UNITED STATES PATENT AND TRADEMARK OFFICE

10/772,979

Office Action Summary	Application No. 10/772,979	Applicant(s) BECKER ET AL.	
	Examiner Darwin P. Erez	Art Unit 3773

DETAILED ACTION

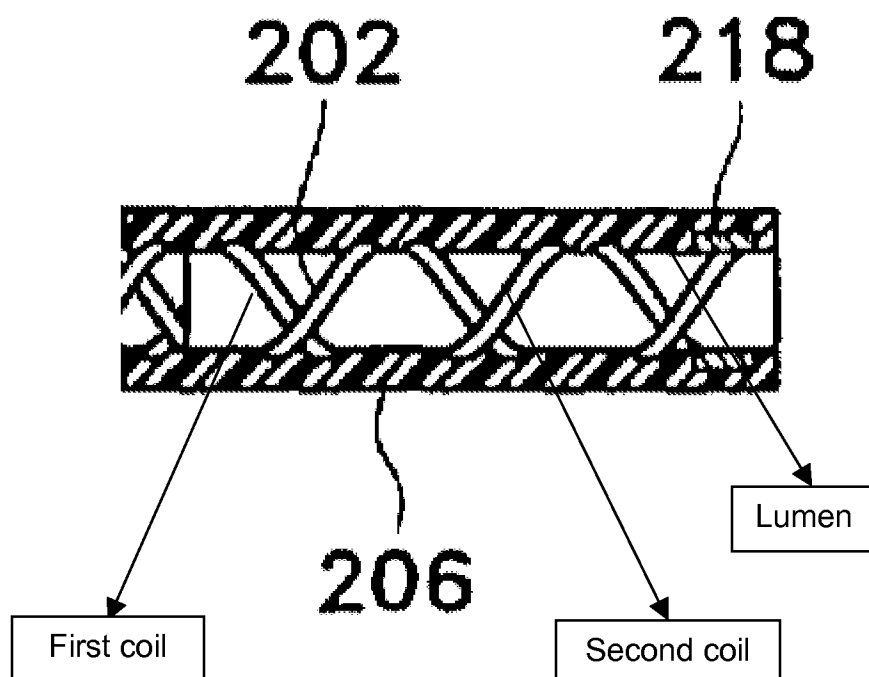
5. (claim 1) The Chien reference discloses a sheath capable of deploying an embolic filter, the sheath comprising:

an elongate shaft **200** having a distal end and a lumen (see Fig. 2);

a coil assembly **202** including:

a first coil defining a lumen, the first coil being wound in a first direction (see attached portion of Fig. 2),

a second coil wound in a second direction, the second coil being disposed around the first coil (as seen below, the second coil is disposed around the first coil);

wherein the coil assembly is attached to the distal end **206** of the shaft, and the lumen of the shaft is in fluid communication with the lumen of the first coil (see attached portion of Fig. 2, below).

Chien discloses a dual coil reinforcement of a hollow tube, wherein the first coil and second coil are braided/weaved around each other. Chien fails to teach the second coil being wound about an outer surface of the first coil.
